# Access Compliance Report

## Public Rights-of-Way

Intersection ID: 10037289	Main Street: SARDIS_RD_NORTH	Cross Street: N/A	Location: SE
ADA ID: 82F1DCD581BB	Ramp Type: Perp	Initial Pass/Fail: Fail	Overall Compliance: No
Codes/Mitigation Info/Possible Solution		Field Measurements/Component Compliance	
Severity Score: 26.25

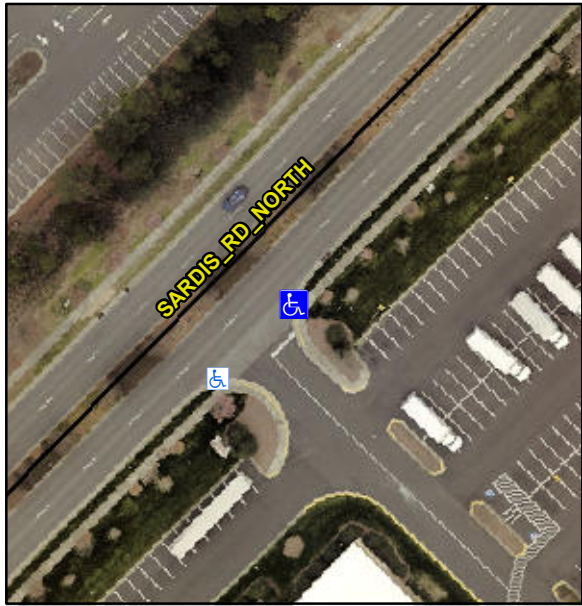
Not Found, R304.2.2, R304.5.3

Compliance	Description	Data	Compliance	Description	Data
N/A	Ramp Length (in)	60.0	No	Ramp Slope (%)	12.0
Yes	Ramp Width (in)	48.0	No	Ramp XSlope (%)	2.8
N/A	Flare Type LT	N/A	N/A	Flare Type RT	N/A
N/A	Flare Slope LT (%)	N/A	N/A	Flare Slope RT (%)	N/A
N/A	Flare Traversable LT?	N/A	N/A	Flare Traversable RT?	N/A
N/A	Landing Length (in)	N/A	N/A	DWS Provided?	N/A
N/A	Landing Width (in)	N/A	N/A	DWS Contrast?	N/A
N/A	Landing Slope (%)	N/A	N/A	DWS Length (in)	N/A
N/A	Landing X Slope (%)	N/A	N/A	DWS Full Width?	N/A
N/A	Landing Curb? (Y/N)	N/A	N/A	DWS Offset (in)	N/A
N/A	Shared Landing?	N/A			
N/A	Gutter Ponding?	N/A	N/A	Gutter Slope (%)	N/A
N/A	Gutter Lip Ht (in)	N/A	N/A	Gutter X Slope (%)	N/A
N/A	Painted X Walk1?	No	N/A	Painted X Walk2?	N/A
	X Walk 1 Direction	To SW		X Walk 2 Direction	N/A
N/A	X Walk 1 Width (in)	N/A	N/A	X Walk 2 Width (in)	N/A
	X Walk 1 Slope (%)	1.9		X Walk 2 Slope (%)	N/A
	X Walk 1 X Slope (%)	0.1		X Walk 2 X Slope (%)	N/A

Remove & Replace Entire Ramp.
